Gateway Generating Station
3225 Wilbur Ave.
Antioch, CA 94509
(925) 459-7200

Subject: Gateway Generating Station (Docket 00-AFC-1C)
Petition to Modify the Gateway Generating Station Project Final Decision to Add Two New Tanks

**Petition to Modify the Final Decision to
Add Two New Water Tanks to the
Gateway Generating Station Project**

FIGURE 1: LOCATION OF PROPOSED WATER TANKS

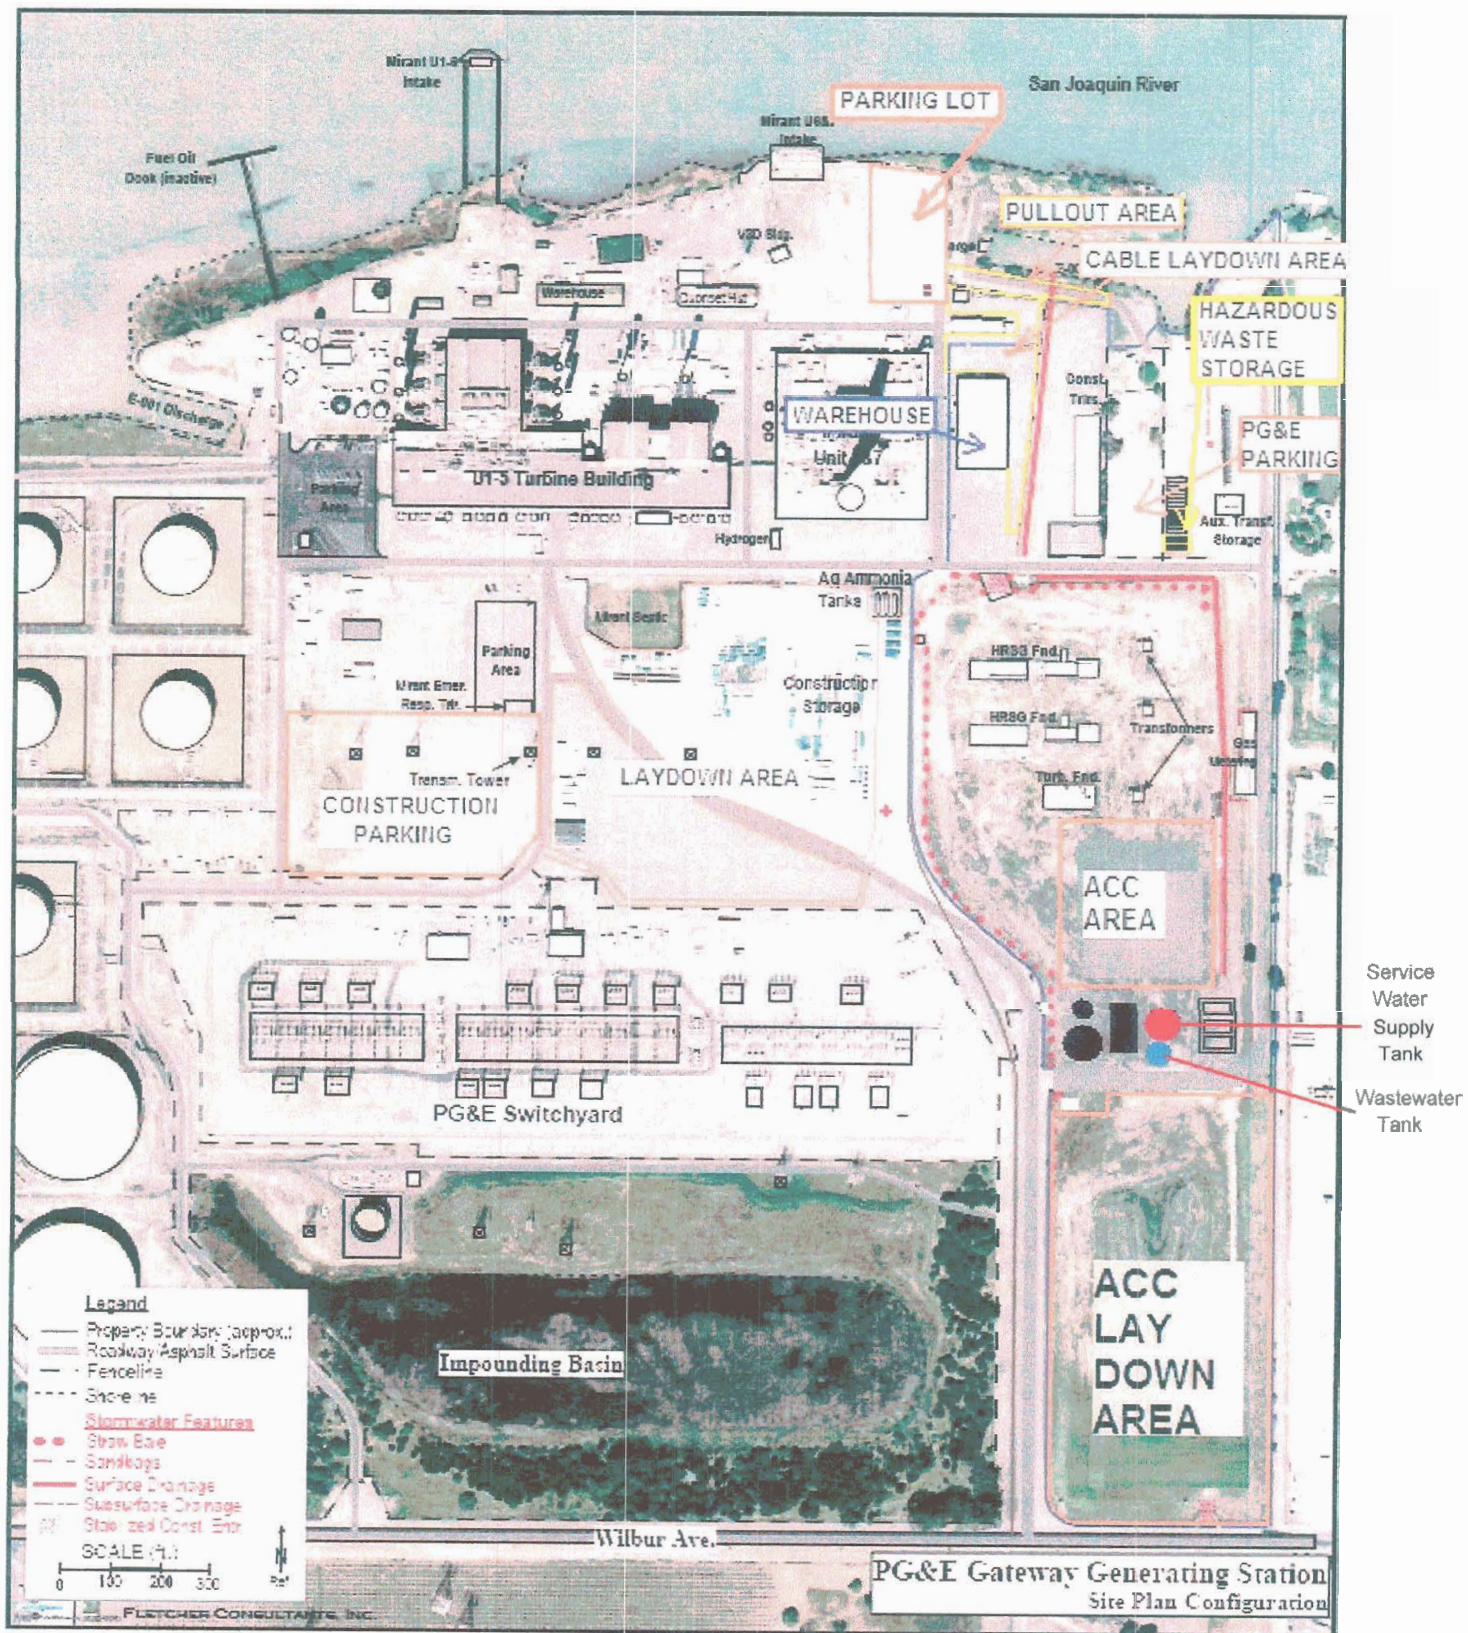
Two new above ground tanks need to be added to the Gateway Generating Station project site: a new 100,000 gallon supply service tank and a new 40,000 gallon wastewater tank. The site configuration diagram (Figure 1) shows the proposed location for the two new tanks, which will be placed in the same area as the fire/service water and demin water storage tanks just south of the ACC structure. These tanks are needed to meet the needs of the water supply purveyor and wastewater discharge receiver. More detailed information on the new tanks is provided in Section 2 of this Petition.

The new supply service tank will be sized to hold up to 100,000 gallons and will be located in the same area as the service/fire water and demin water storage tanks, just south of the air cooled condenser (ACC) (see Figure 1). The dimensions of the service supply tank are approximately 29 feet in diameter and 22 feet high; the tank will be back dropped by the ACC structure, which is approximately 281 feet wide and 130 feet high. The piping associated with the service water supply tank is an internal loop system and will not require any additional linear piping segments out to Wilbur Avenue. The service supply tank will be constructed in January 2008.

The wastewater storage tank will be sized to hold approximately 40,000 gallons of wastewater. The tank will be located in the same area as the previously approved tanks (one service/fire water tank and one demin water storage tank) that will be located just south of the air cooled condenser (ACC). The dimensions of the wastewater tank will be approximately 21 feet in diameter and 18 feet high and will be back dropped by the ACC structure. The discharge piping associated with the wastewater storage tank will be placed underground in the same trench as the fire/service water line; the pipe will connect to the City of Antioch sewer main located in Wilbur Avenue directly in front of the GGS project site. The wastewater storage tank will be constructed in January 2008.
